Revised Parking Bryneithin, Dinas Powys

Arboricultural Impact Assessment

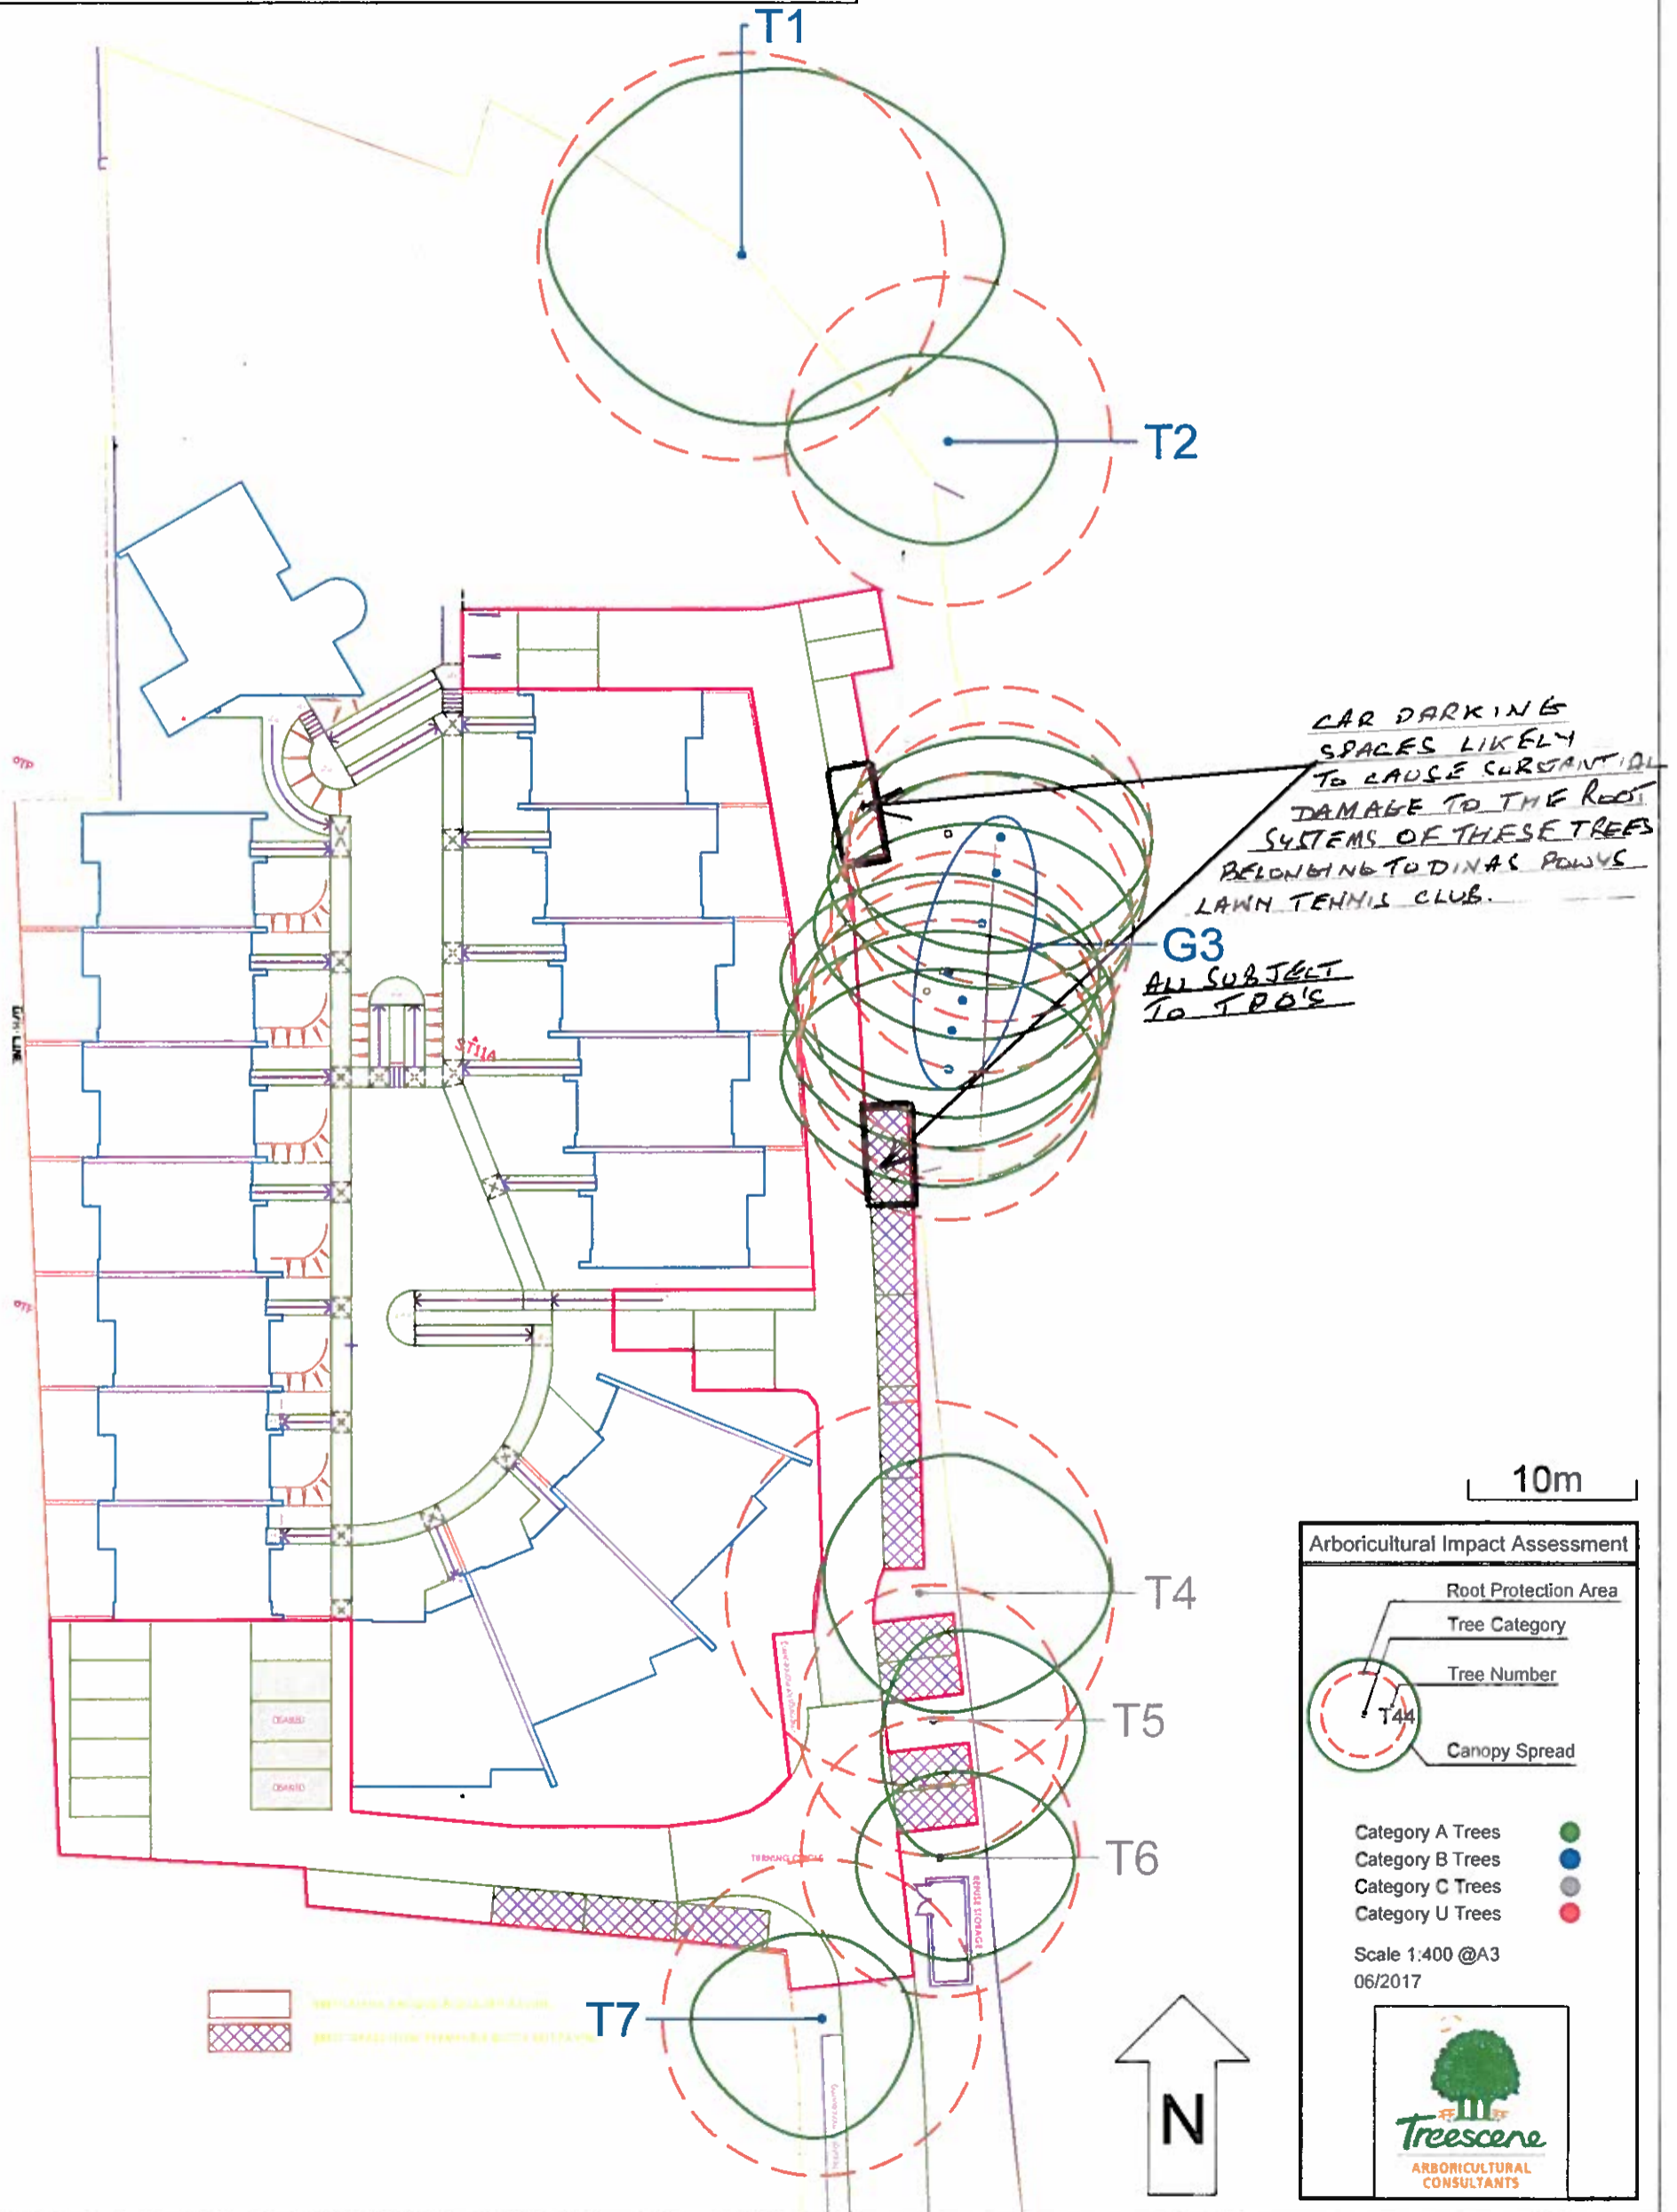
CAR PARKING SPACES LIKELY TO CAUSE SUBSTANTIAL DAMAGE TO THE ROOT SYSTEMS OF THESE TREES BELONGING TO DINAS POWYS LAWN TENNIS CLUB.

G3
ALL SUBJECT TO TPO'S
